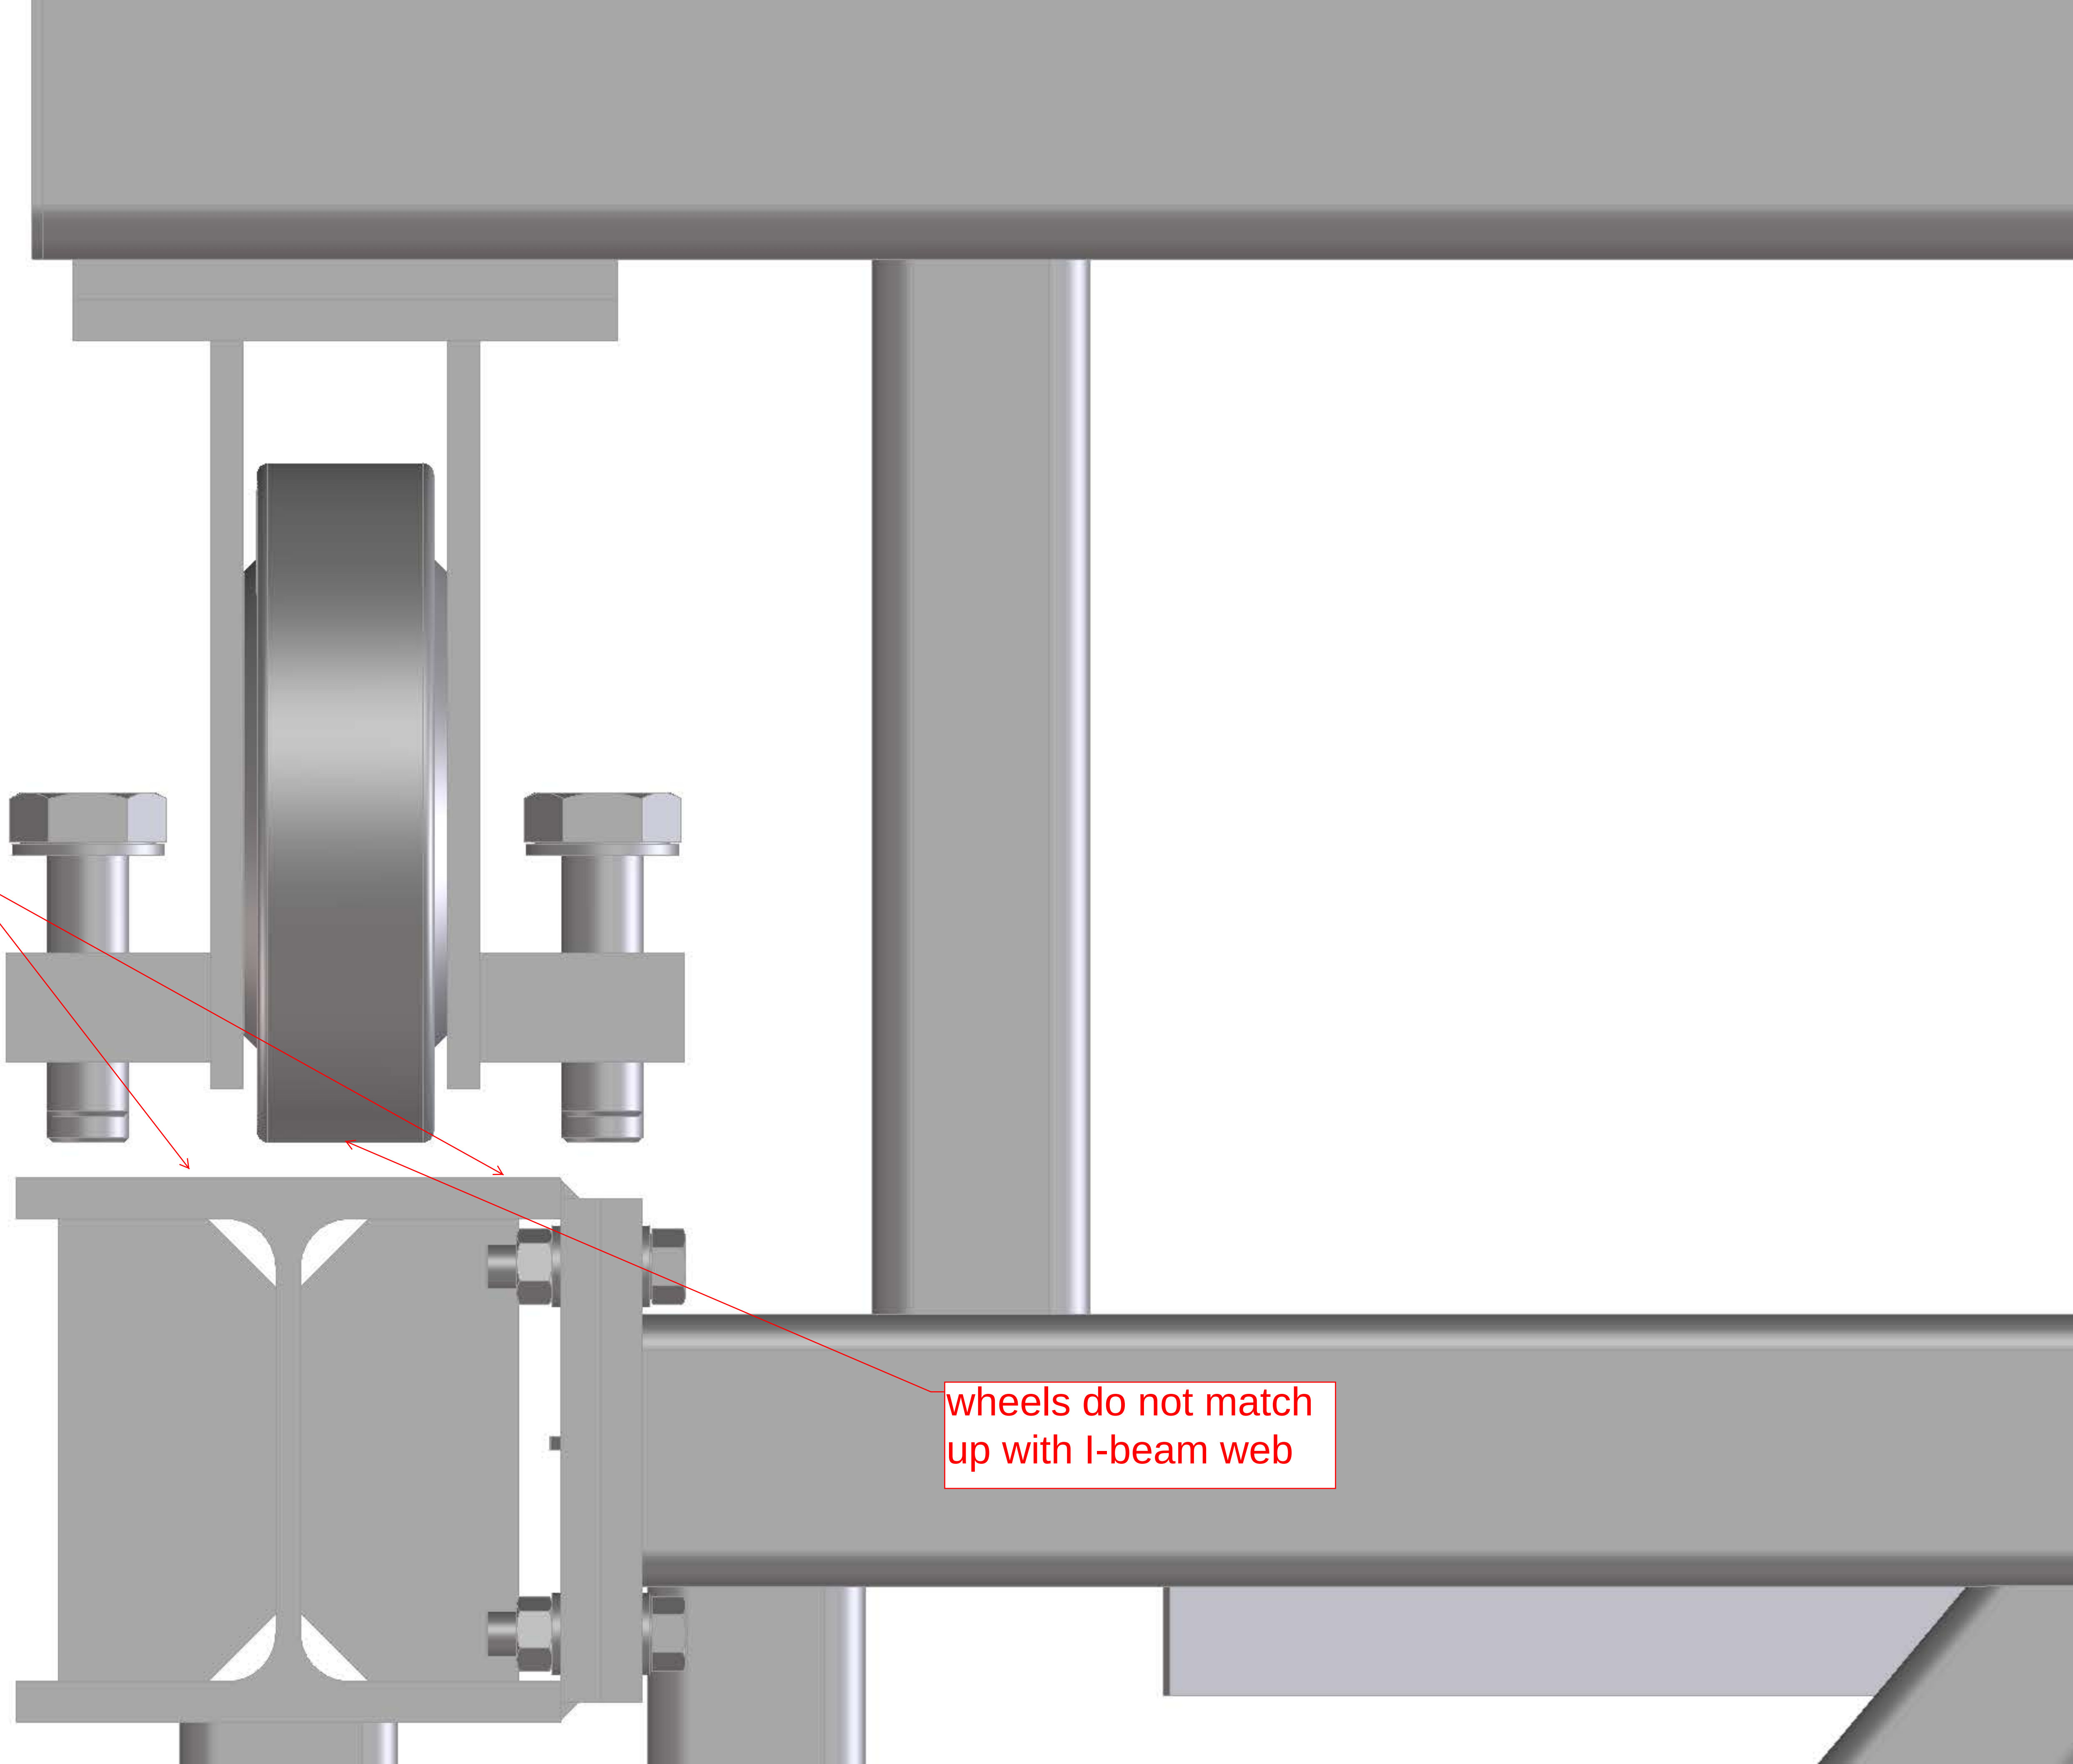
this pipe not used

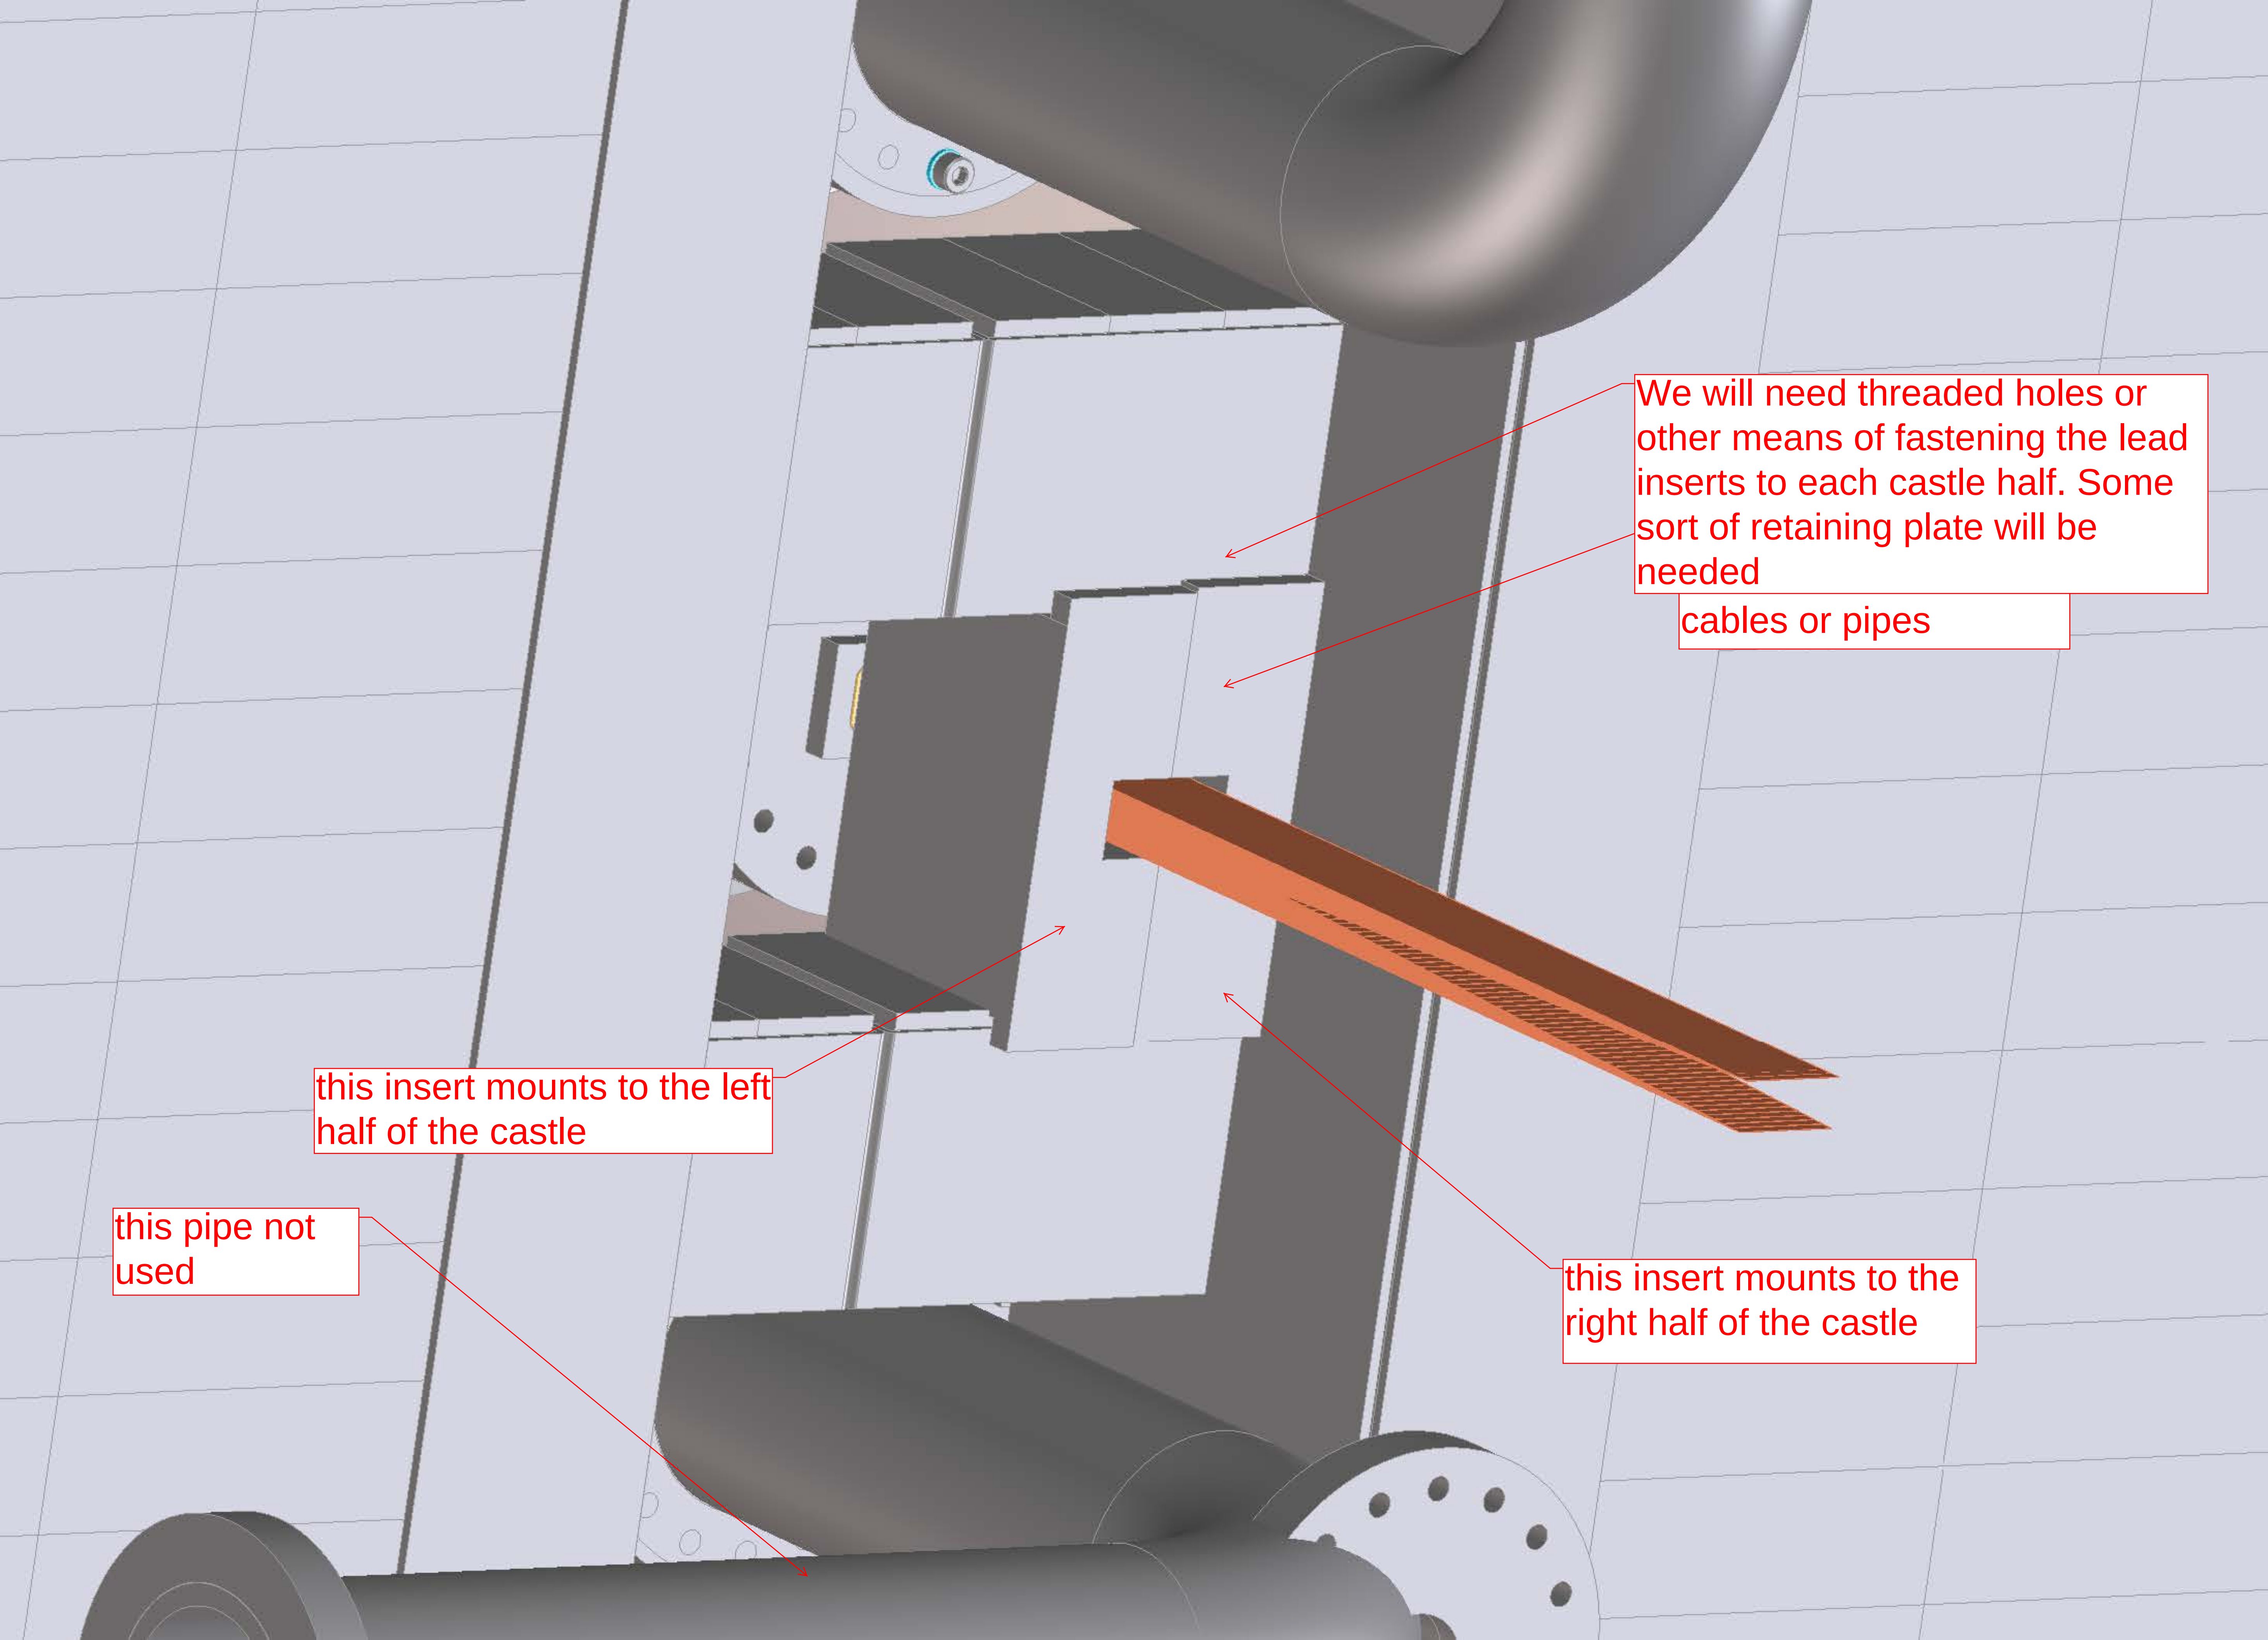
this aperture not needed

this pipe not used

are there
wheel guides
here?

wheels do not match
up with I-beam web

We will need threaded holes or other means of fastening the lead inserts to each castle half. Some sort of retaining plate will be needed

cables or pipes

this insert mounts to the left half of the castle

this pipe not used

this insert mounts to the right half of the castle
